## SERVICE BULLETIN

**APPLICABILITY:** 2015-2017MY Outback Models  
2017MY Impreza 5-Door Models

**NUMBER:** 15-212-17

**SUBJECT:** Tonneau Cover Handle- Design Change

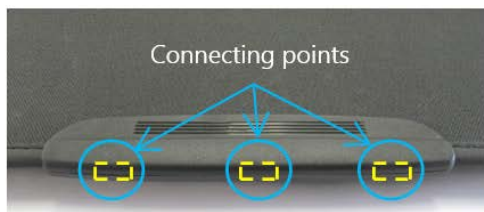
This bulletin announces a design change of the tonneau cover assembly to address customer concerns of the handle portion coming loose. The handle has been changed to optimize retention and made available as a service part separate from the tonneau cover.

Tonneau covers with the new handle were incorporated into production during Mid-June, 2017.

The part number for the replacement handle is: **65593AL000**.

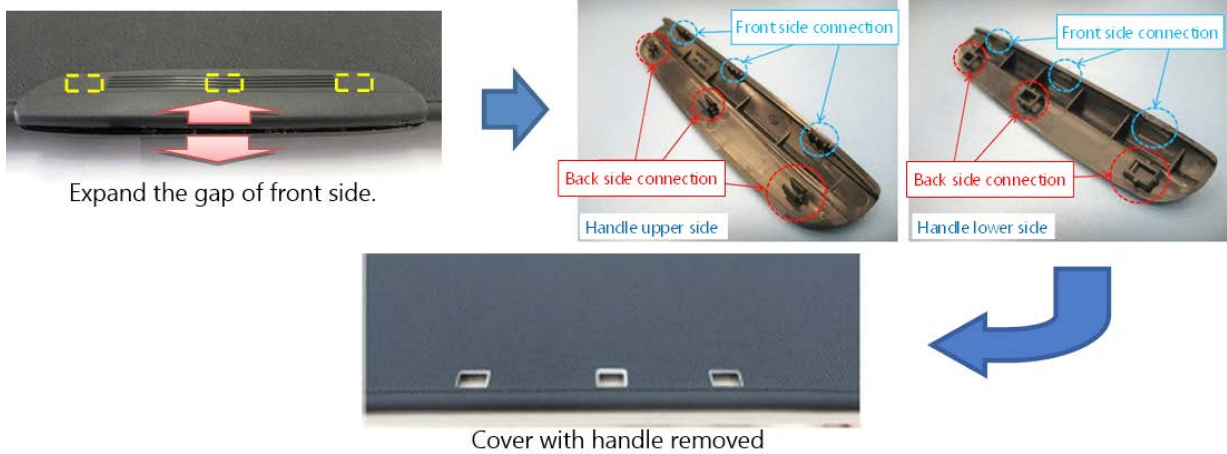
1. The handle consists of a top and bottom “half” which sandwich the tonneau cover itself. There are 6 connecting points holding the halves of the handle together. Release the 3 back side points using a plastic Trim tool.

Turn the Trim tool to remove each clip.

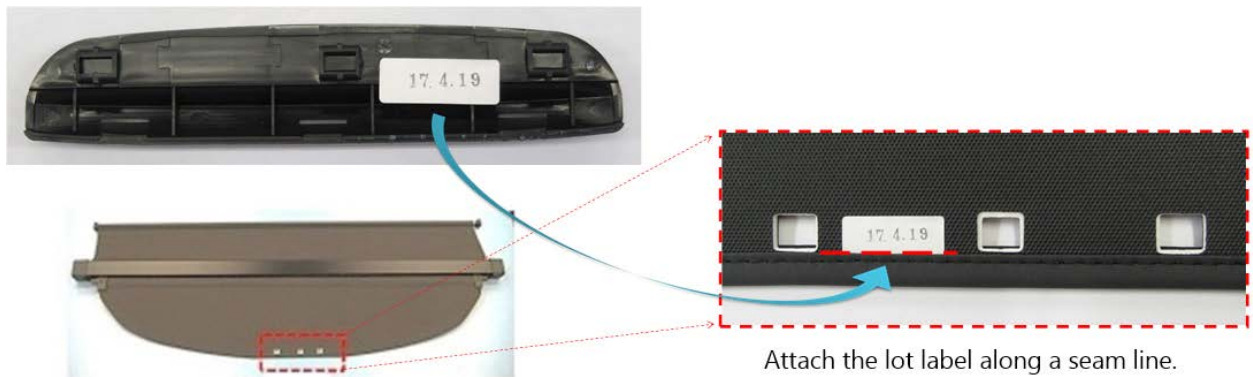
2. Expand the gap made after releasing the 3 back side connecting points to access and release the 3 front side connections located further inside the handle.

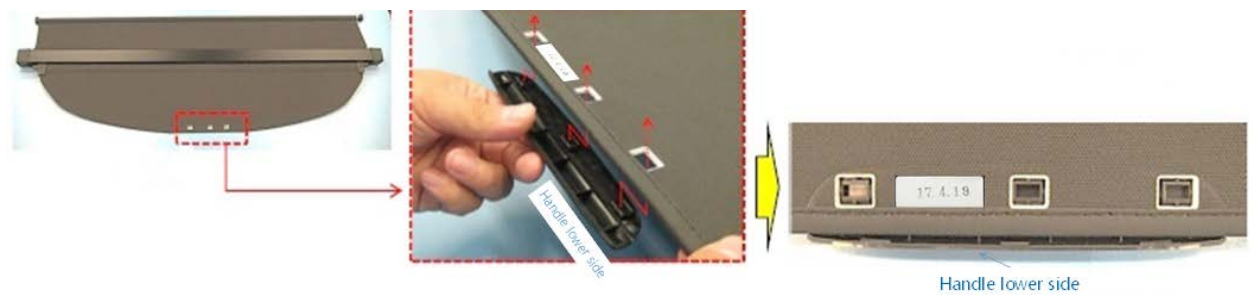
3. For future tracking purposes, transfer the lot label from the handle to the cover along the seam line.

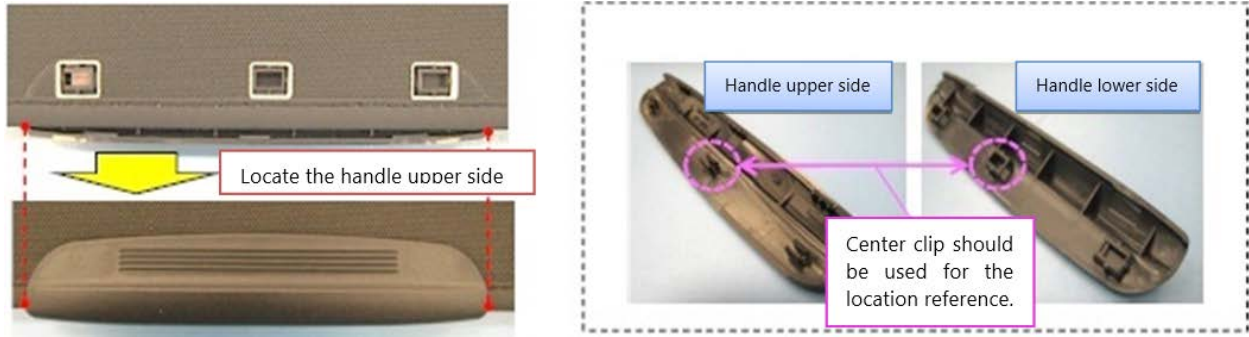
4. Assemble the new handle on the tonneau cover starting with the bottom half. Align the 3 connecting points with the 3 holes in the cover.

- Align the upper half of the new handle with the 3 lower half connecting points. Use the center point as a reference for proper location.

- Clip the center connecting point closed first then each of the 2 outside points.
